Title - Sujet Canopy Coating Remediation	
Solicitation No. - N° de l'invitation EZ899-180576/A	Amendment No. - N° modif. 004
Client Reference No. - N° de référence du client	Date 2017-08-03
GETS Reference No. - N° de référence de SEAG PW-\$PWY-019-8114	
File No. - N° de dossier PWY-7-40084 (019)	CCC No./N° CCC - FMS No./N° VME
Solicitation Closes - L'invitation prend fin at - à 02:00 PM on - le 2017-08-09	Time Zone Fuseau horaire Pacific Daylight Saving Time PDT
F.O.B. - F.A.B. Plant-Usine: <input type="checkbox"/> Destination: <input checked="" type="checkbox"/> Other-Autre: <input type="checkbox"/>	
Address Enquiries to: - Adresser toutes questions à: Ngan, Ken (PWY)	Buyer Id - Id de l'acheteur pwy019
Telephone No. - N° de téléphone (604) 671-0219 ()	FAX No. - N° de FAX (604) 775-6633
Destination - of Goods, Services, and Construction: Destination - des biens, services et construction: Canopy Structural Coating Remediation – Douglas Port of Entry (PoE) - 220 Highway 99 - Surrey, BC

This Solicitation Amendment 004 is raised to incorporate Addendum No. 2.

Please find following Addendum No. 2.

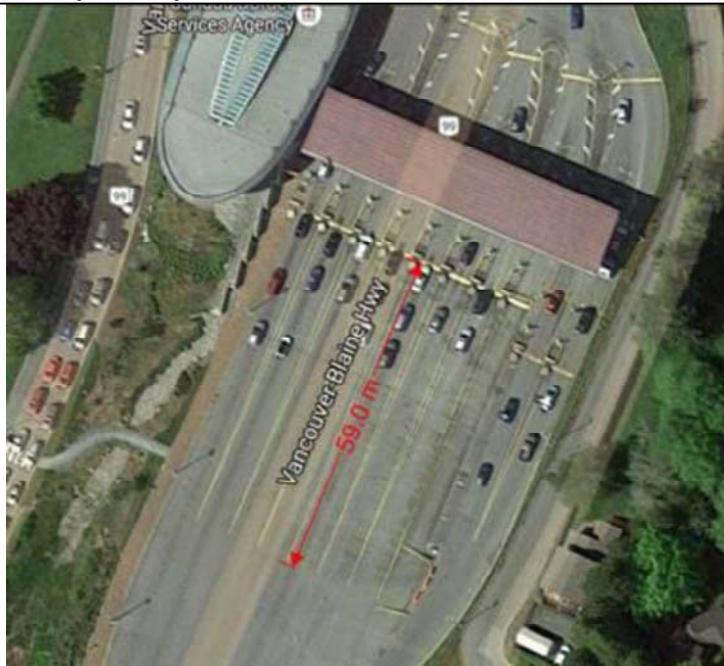
- Q.5 How far from the PIL will traffic need to be diverted into operating lanes? Will temporary signage be required by contractor to divert traffic into operating lanes or will CBSA handle this? if by contractor will cone system be sufficient?
A.5 *Temporary signage will not be required, however cones and/or barricades are to be placed by Contractor to direct traffic towards the operating lanes. To successfully divert traffic into operating lanes without issue, barriers need to be started at a minimum at the beginning of the painted lane lines, and an additional 15-30m at the Nexus lanes where the concrete curbing is located. See the following image for reference.*
